Historic Preservation Board

**STAFF MEMORANDUM
HISTORIC PRESERVATION PROGRAM
PLANNING AND URBAN DEVELOPMENT**

TO: Chair O'Brien and Members of the Historic Preservation Board
FROM: Rob Wiener, Historic Preservation Compliance Coordinator
DATE: January 13, 2023
RE: Western Cemetery (6 Vaughan Street) New Construction of Tool House - PH
PROJECT ID: HPBR-001913-2022
MEETING: January 18, 2023

Replacement of a Tool House
at the
Western Cemetery
Portland, Maine

Building Plan
Material Specs

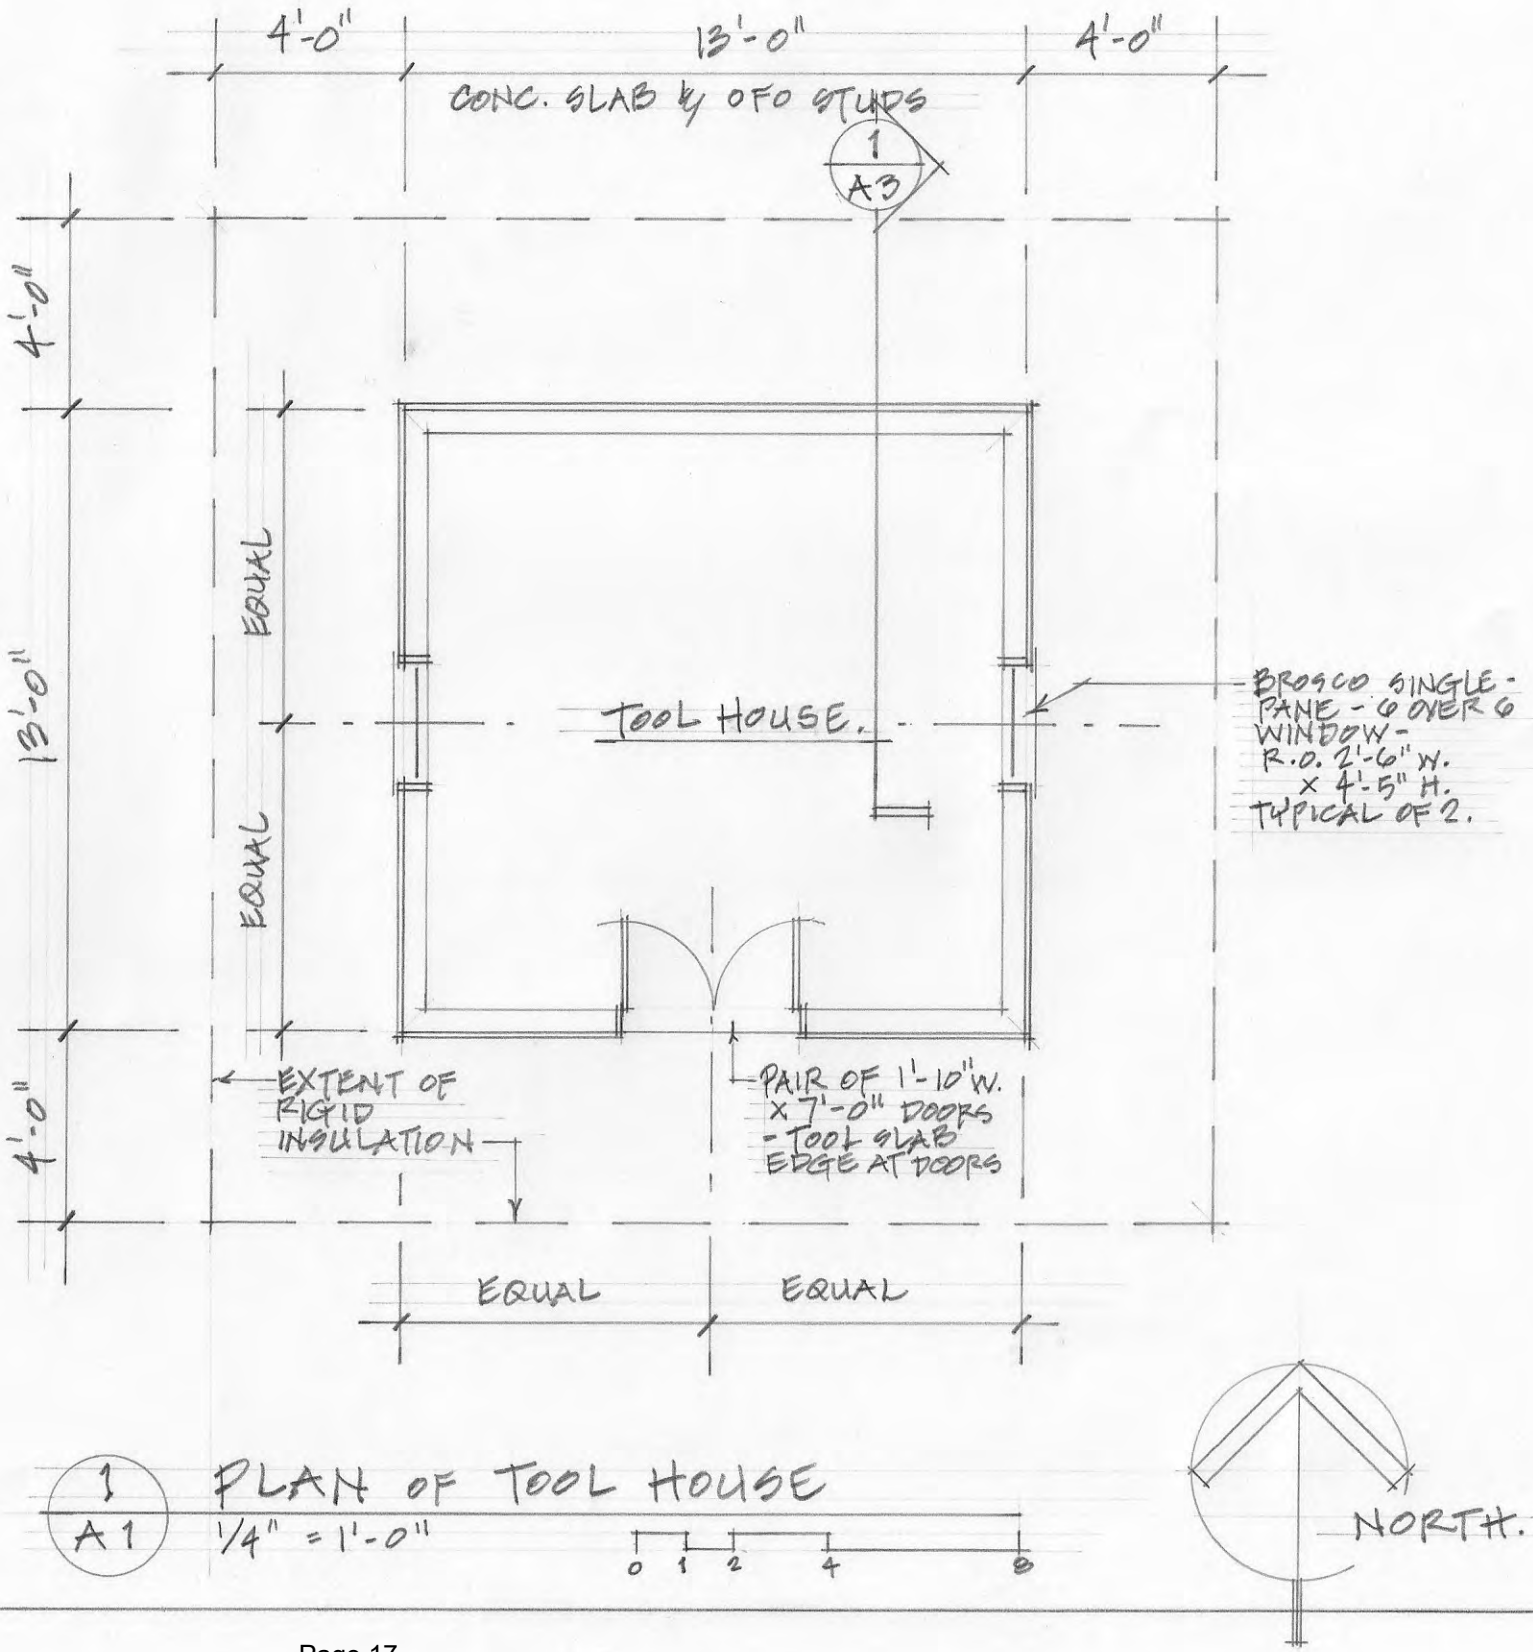
Change from wood to modern composite materials

LP SmartSide products, limited color choices, selection to be determined and:

James Hardie products, primed, on site final coats, paint colors to be determined Specifications for each:

SmartSide by LP SMOOTH TRIM	James Hardie SMOOTH TRIM
Vertical Boards	440 Series 11/16" thick 9-3/16" wide	4/4 Series 3/4" thick 9-1/4" wide
Vertical Battens	440 Series 11/16" thick 1-3/4" wide - use 3-1/2" trim ripped in half - no chamfers	4/4 Series 3/4" thick 1-3/4" wide - use 3-1/2" trim ripped in half - no chamfers
Water Table	540 Series 31/32" thick 9-3/16" wide	5/4 Series 1" thick 9-1/4" wide
Soffit Boards	440 Series 11/16" thick 11-3/16" wide - cut to fit	4/4 Series 3/4" thick 11-1/4" wide - cut to fit
Corner Boards	440 Series 11/16" thick 3-1/2" wide	4/4 Series 3/4" thick 3-1/2" wide
Eave & Rake Trim	440 Series 11/16" thick 3-1/2" wide - over - 540 Series 31/32" thick 9-3/16" wide - both cut to fit at eaves	4/4 Series 3/4" thick 3-1/2" wide - over - 5/4 Series 1" thick 9-1/4" wide - cut to fit at eaves

ROOF SYSTEM NOTES -

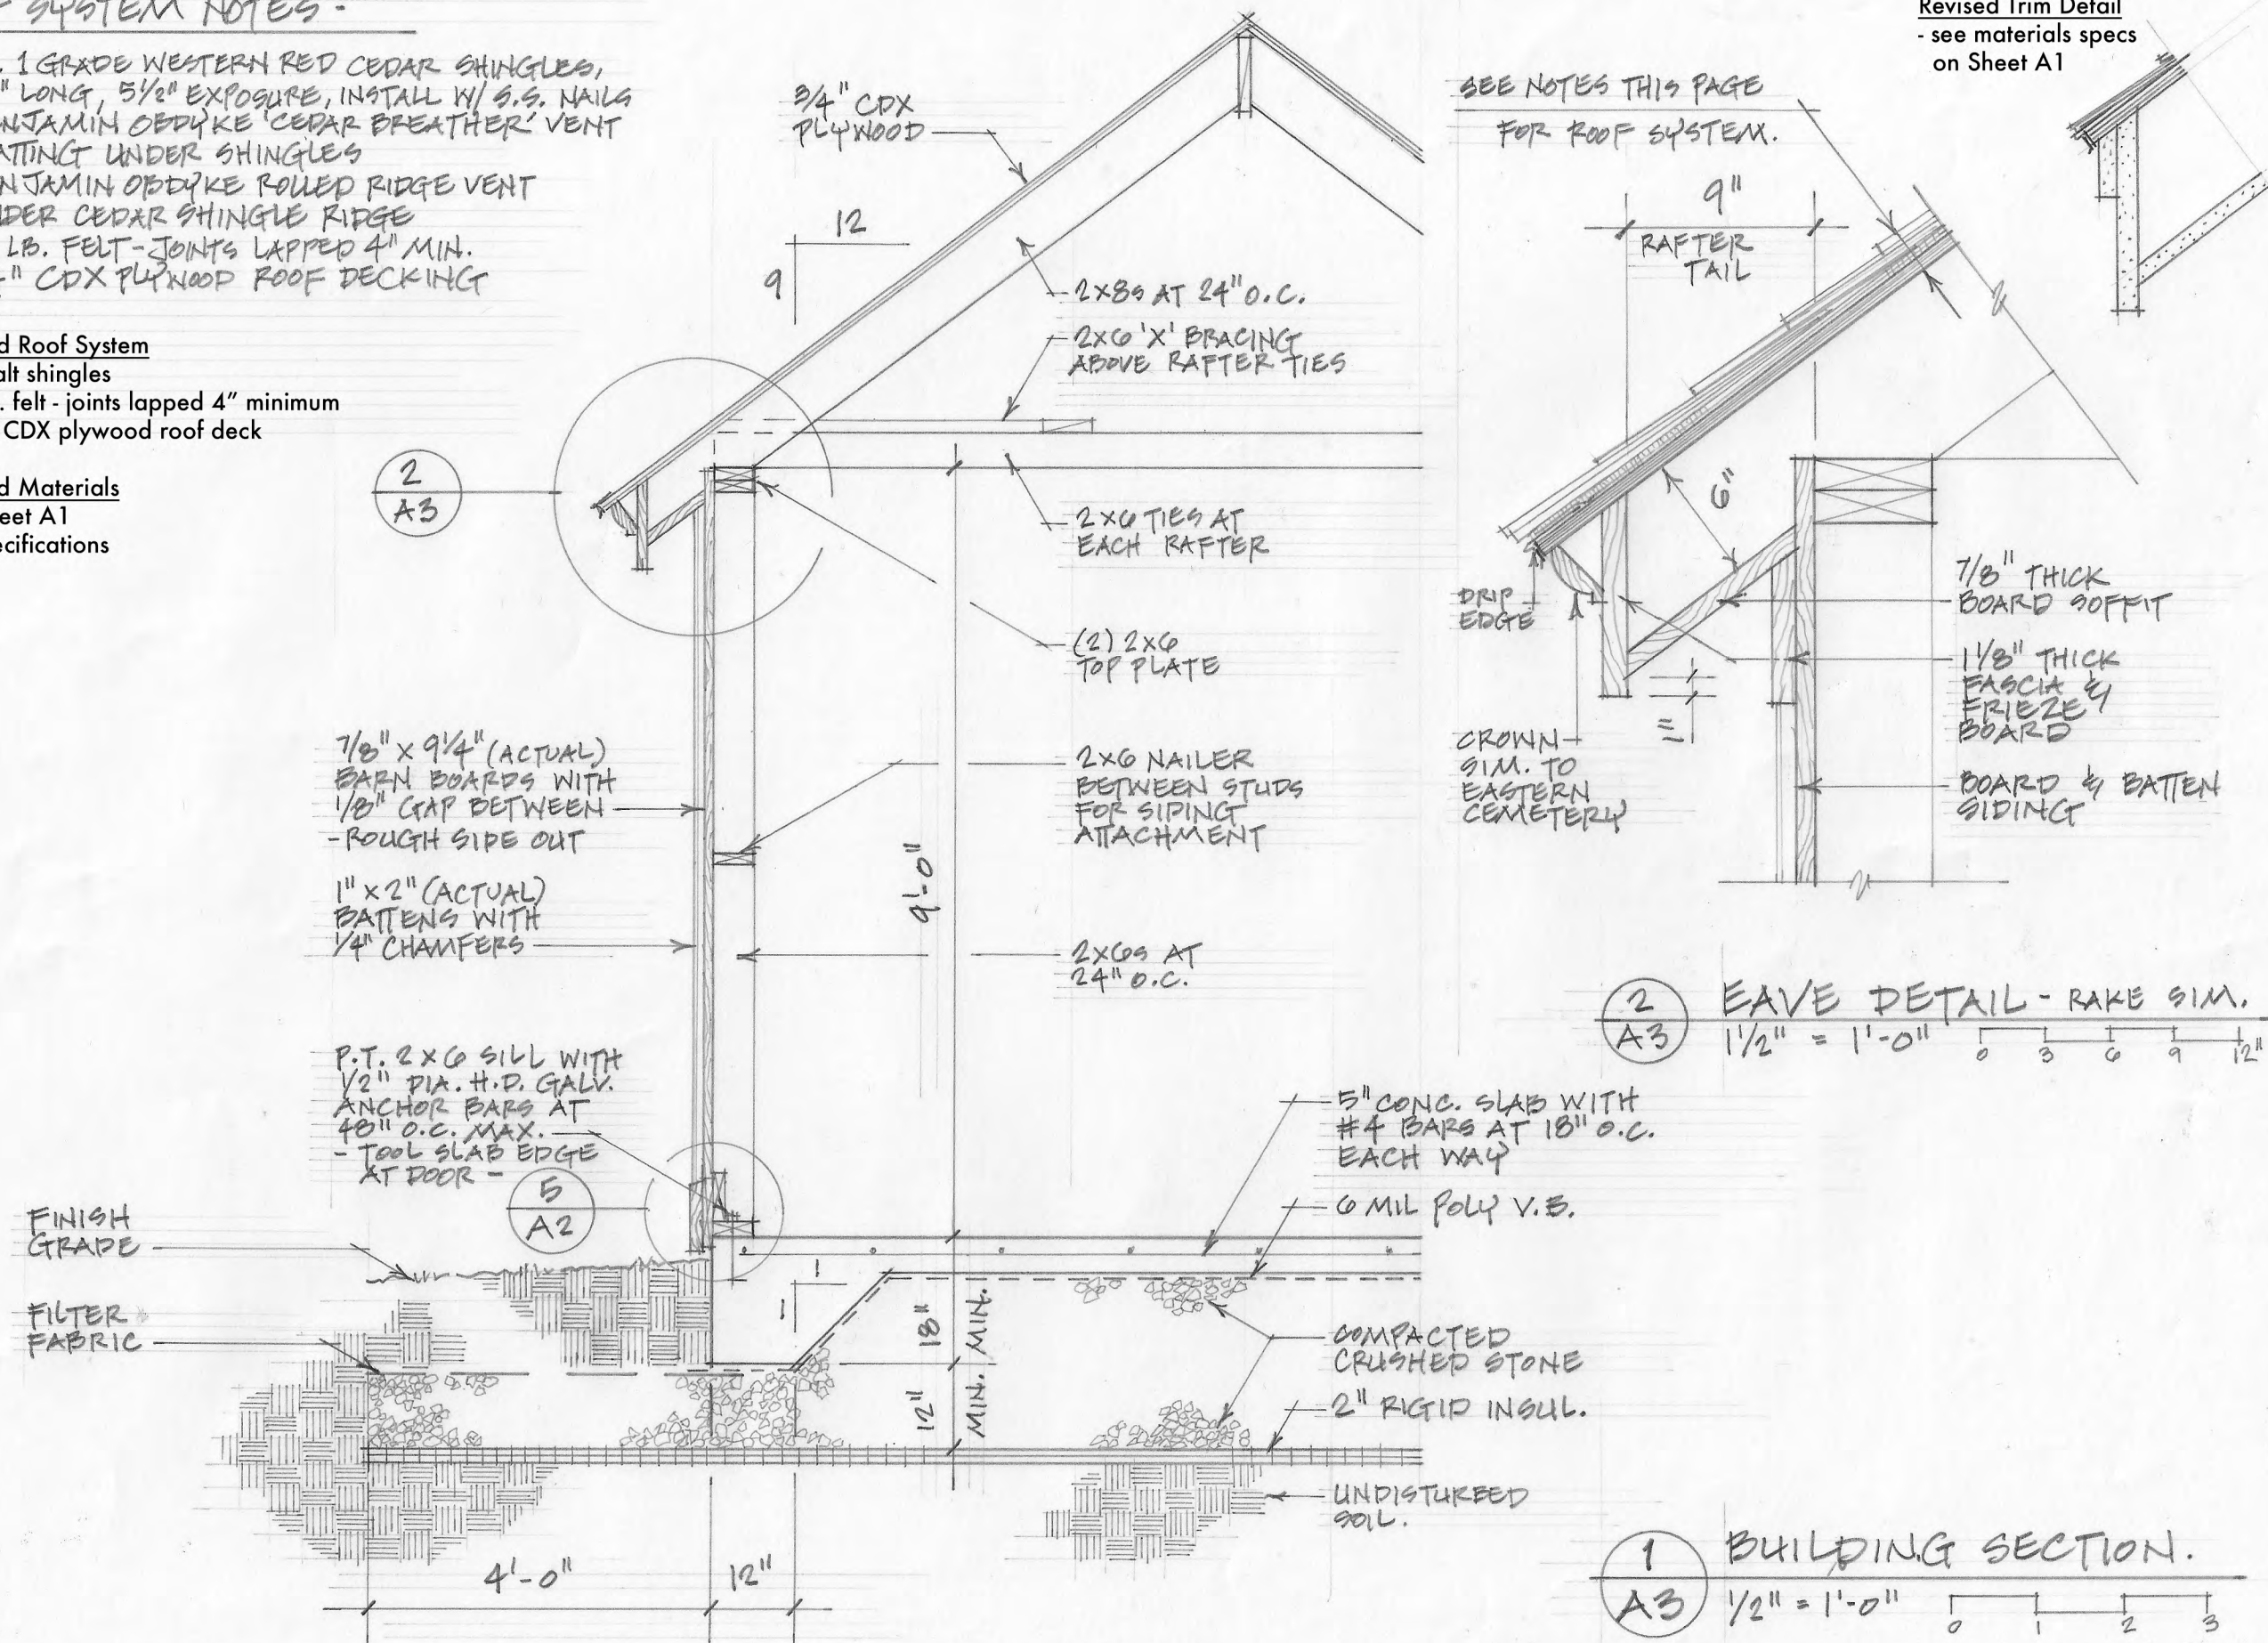
Change from Western Red Shingles to Asphalt Shingles, product to be determined, no venting required

Revised Roof System

- NO. 1 GRADE WESTERN RED CEDAR SHINGLES, 18" LONG, 5 1/2" EXPOSURE, INSTALL W/ S.S. NAILS
- BENJAMIN OBDYKE 'CEDAR BREATHER' VENT MATING UNDER SHINGLES
- BENJAMIN OBDYKE ROLLED RIDGE VENT UNDER CEDAR SHINGLE RIDGE
- 30 LB. FELT - JOINTS LAPPED 4" MIN.
- 3/4" CDX PLYWOOD ROOF DECKING

Building Section
Eave Detail

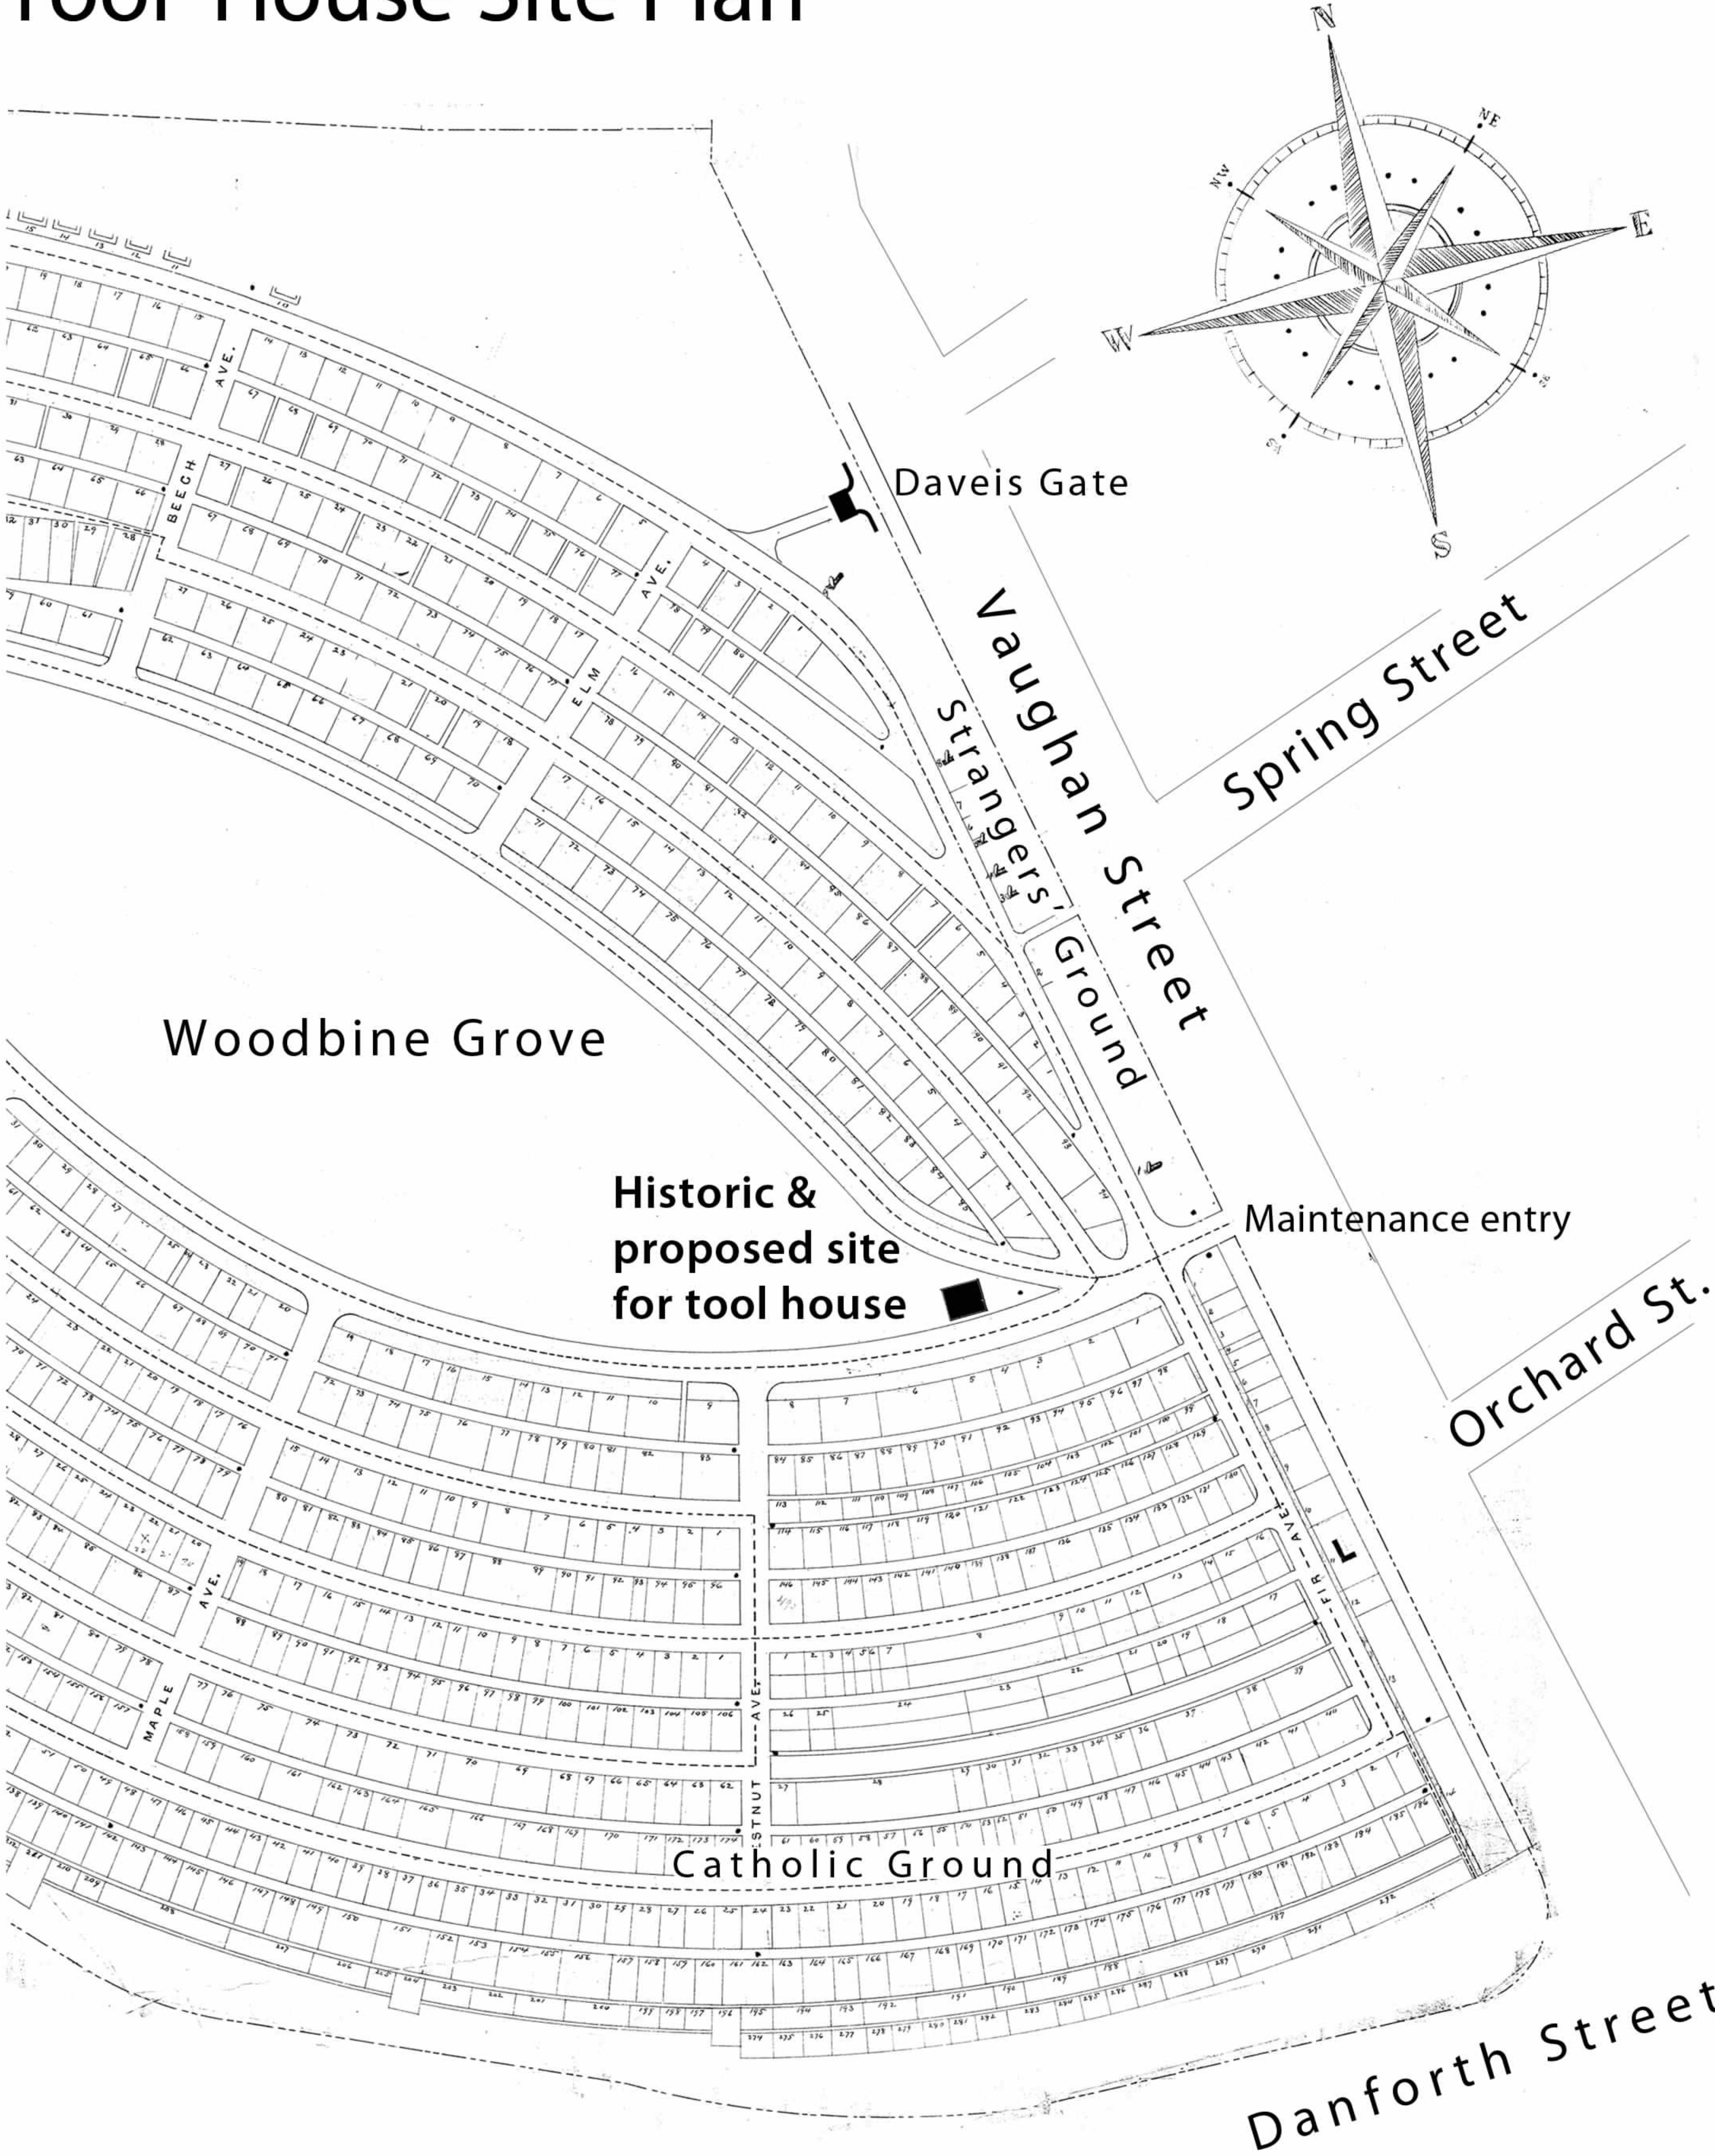
Revised Trim Detail
- see materials specs
on Sheet A1

Revisions
12-27-2022
See typed notes

2/A3 EAVE DETAIL - RAKE SIM.
1 1/2" = 1'-0" 0 3 6 9 12"
